## MEMORANDUM

**Re:** Centennial Elementary School District 135  
Proposed Exit Drive  
Orland Park, Illinois

**Exhibit 2:** Vehicular Conflict Points

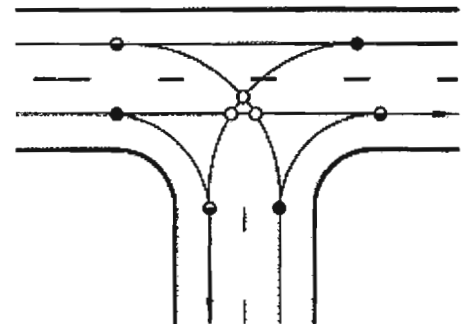
At a typical “T” intersection or driveway, there are nine conflict points between vehicles turning into and out of the driveway (See **Exhibit 2**). There are two additional conflict points for the pedestrians crossing the inbound and outbound traffic.

**Exhibit 5: Inbound Only Vehicular Conflicts**

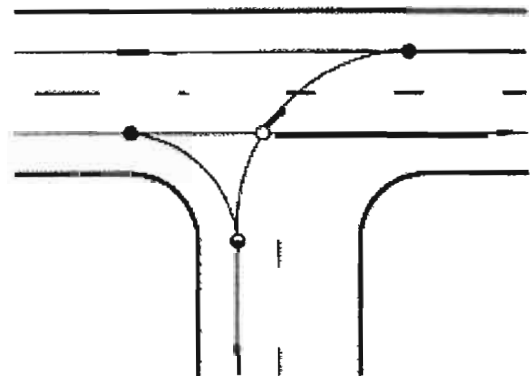
Parents would enter the staff lot as they currently do from both directions and use the loading zone on the west side of the site. Instead of going back to Brigitte Lane, they would head east to Haverhill Lane to exit. This will separate traffic flows, reduce conflicts and improve safety. The Brigitte Terrace drive will only allow inbound traffic and reduce the number of conflicts from 9 to 4 locations (see **Exhibit 5**).

#### **Exhibit 6: Outbound Only Vehicular Conflicts**

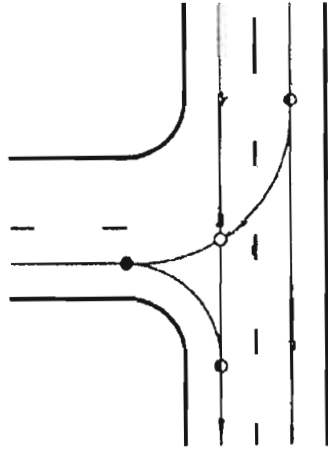
The Haverhill Lane drive will be exit only which will also reduce the number of conflicts from 9 to 4 (see **Exhibit 6**). The new drive is located 270 feet south of Brigitte Terrace which aligns with the south side of the lot and is far enough away from the intersection for good traffic flow.
